Subject: VEHICLE SPEED DOES NOT INCREASE WITH ENGINE SPEED AND ATX DOES NOT SHIFT UP OR DOWN	Bulletin No: 05-002/14
	Last Issued: 02/14/2014

- This bulletin supersedes the previous bulletin 05-008/13, issued on 12/12/13. The APPLICABLE MODEL(S)/VINS has been revised.
- Changes are noted below in Red beside the change bar.

Fail-safe function operation:

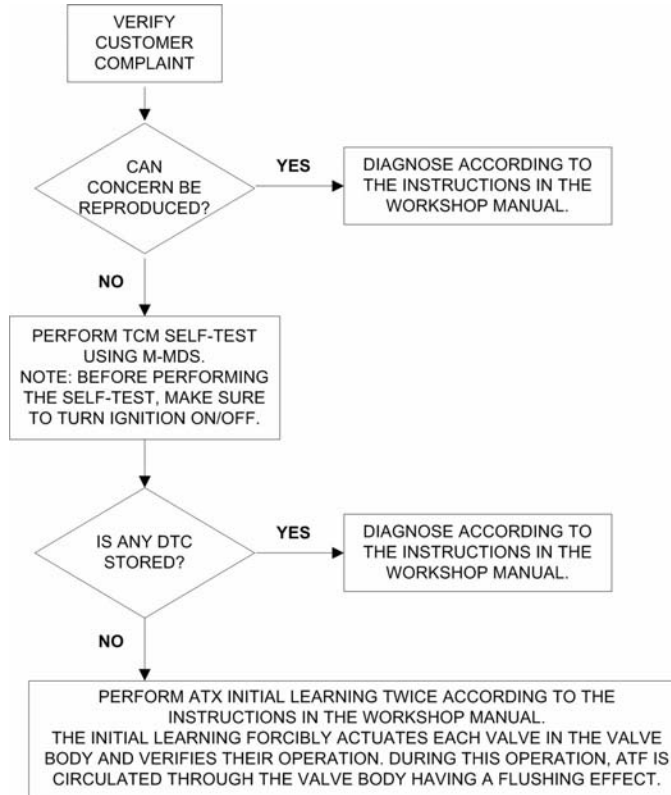
- If a technical fault is detected in the ATX by the malfunction detection function, the fail-safe function limits the ATX control (inhibits some gears or shift down functions).
- Even in case of an ATX malfunction, the fail-safe function allows minimum vehicle driveability.
